Model Review and Clarification for:

Hydraulic Models of the Congaree River in Richland and Lexington Counties, SC

Tuesday, April 24, 2001

Figure 1: Mesh used in FEMA study

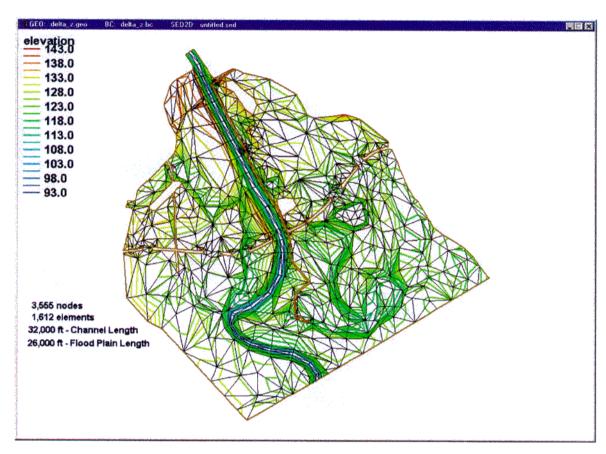
The FEMA study was based on finite element meshes originally constructed in 1981 by the USGS. For the study, two meshes where merged into one. The merged mesh is shown in Figure 1. The study is described in a report entitled "Appeal Resolution for Congaree River in Richland and Lexington Counties, South Carolina" dated September 26, 2000.

The FEMA study made use of an existing mesh in order to be efficient. This resulted in the model being limited to the resolution and extents of the older mesh. As has been mentioned, the downstream boundary condition was lower than was justified. A lower water surface would naturally result in higher velocities. The FEMA study used these higher velocities to delineate effective flow regions for the one-dimensional model. A larger effective flow region in the one-dimensional model results in a larger floodway. Therefore, the final conclusions of the FEMA study were significantly affected by the limitations of the old mesh.

Figure 2: Mesh used in Exponent study

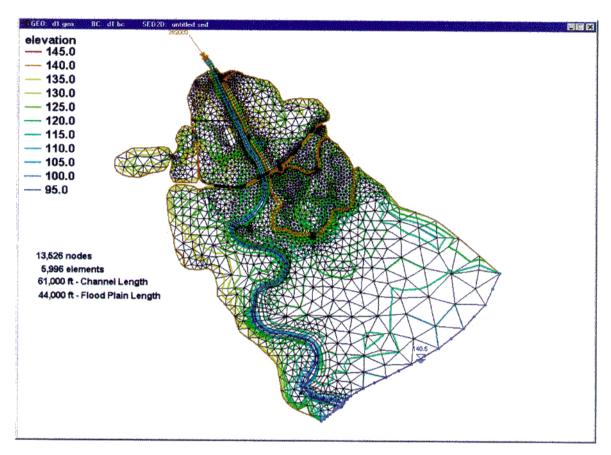
An expanded and refined finite element mesh was constructed for the Exponent study. This mesh is shown in Figure 2. The Exponent study is described in a report entitled "Expanded Two Dimensional Flow Analysis and Determination of No Floodway for the Congaree River Floodplain in Richland County, South Carolina", dated February 12, 2001.

Several minor refinements to the Exponent mesh were suggested during the course of this review. These included some poorly formed elements, and numerical convergence concerns. Each problem was easily resolved and had no significant impact on the model results.

Figure 3: Difference in ground elevations.

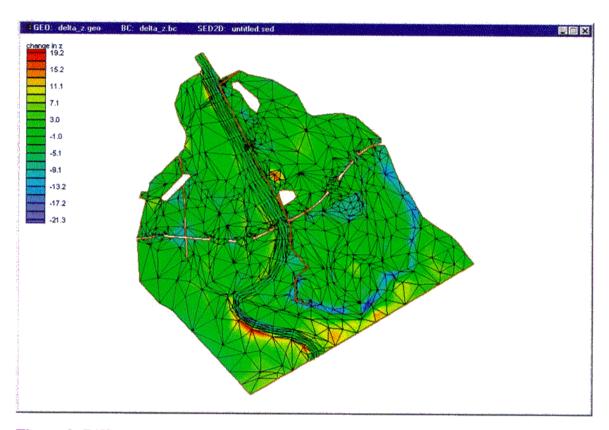
Underlying Data: No numerical model is better than the data used to construct the model. The geometry of a finite element mesh has by far the greatest impact of the accuracy of a numerical model. In the FEMA study, the principal source of bathymetric data was from the 1981 USGS study. FEMA indicated that they had compared these data with updated contour maps to check elevations, and this resulted in higher elevations in some of the areas behind Manning Levee. The Exponent study used entirely new geometric data obtained from recent surveys. Comparison of the geometry (Figure 3) show that in the principal areas the ground elevation used are very similar. The blue areas below the I-77 embankments illustrate the difference in representation of the Gill Creek Levee. The FEMA study has higher ground elevations, whereas the Exponent study modeled the levee as a flow restricting feature (similar to the I-77 embankment). The biggest difference is the extent of the data. Figure 3 shows the extent of the FEMA study, because that is where a comparison can be made. However the Exponent study extends 16,000 ft further down the floodplain.

Figure 4: Mesh quality warnings

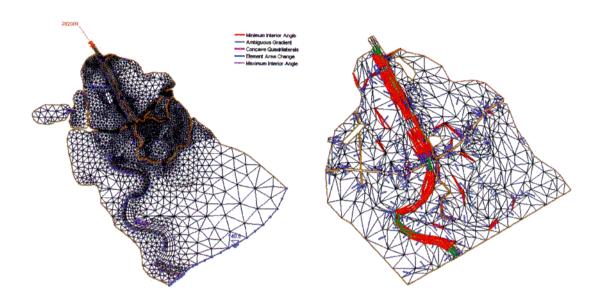
Mesh Quality: Mesh quality includes analysis of element quality, element density and resolution, and domain extents. The shape, quality, and number of elements in an RMA2 model have an affect on its stability and validity of the model results. Skewed triangular elements in particular with interior angles less than about 10° can produce erroneous results. SMS includes an option to display warnings about mesh elements that violate these rules. Figure 4 shows the warnings that were generated for the standard recommendations in SMS for the two meshes. In these pictures, any color indicates a possible concern. These figures indicate a superior quality of the Exponent mesh.

Figure 5: Velocity magnitude parallel to the river.

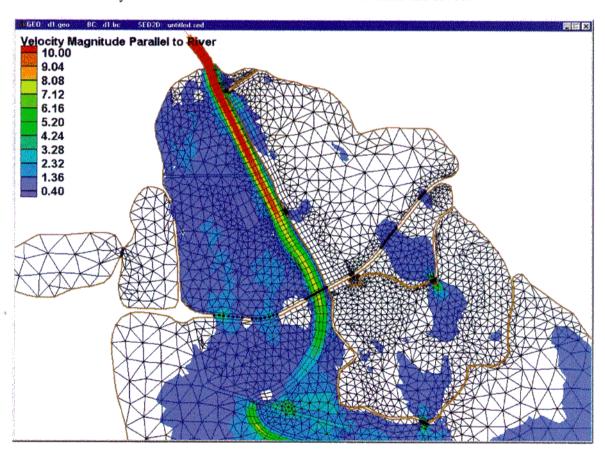
When determining if the flow in the Richland County floodplain is a floodway, the flow conditions need to be examined. If there is no efficient flow, there cannot be floodway. The FEMA study established a 1 ft/sec velocity magnitude for effective flow. However, behind the Manning Levee, the flow direction is not parallel to the river. The velocity magnitude parallel to the river can be computed using the tools inside SMS. For the 1% flow rate, for what Exponent called CASE 3 (two breaches of Manning Levee), the areas where water is moving parallel to the river faster than 0.4 ft/sec are shown in Figure 5. This figure shows that water does not flow in an efficient manner that would be expected in the floodway. This clarifies the condition of flow behind the levee.

Historical Factors

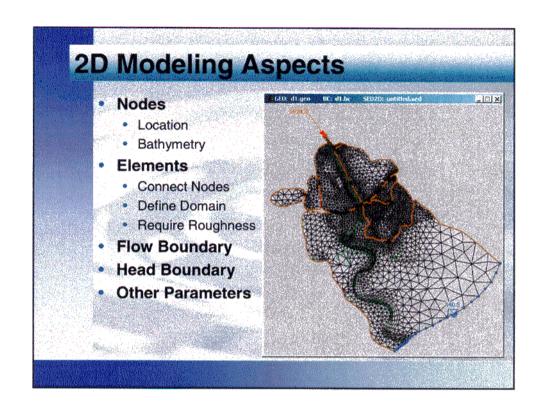
By strict definition, Manning Levee is not a 100 year levee, and therefore could be ignored when computing a floodway for the Congaree River. However, it has not been ignored in other hydraulic design considerations over the past several decades. The I-77 relief openings were obviously designed without a floodway in mind. This is evidenced by the fact that the large 1300-foot relief opening is not positioned near the river (which probably would create an efficient floodway), but rather in the middle of the floodplain. While it is true that a Manning Levee breach is expected during the 1% event, and that such a breach will allow up to 9% of the flood waters to pass through Richland County, it is also true that the levee significantly modifies the hydraulic nature of the floodplain. It does this by its own existence as well as through the influence it has had on other levees and embankments that have been added to the floodplain since it was built.
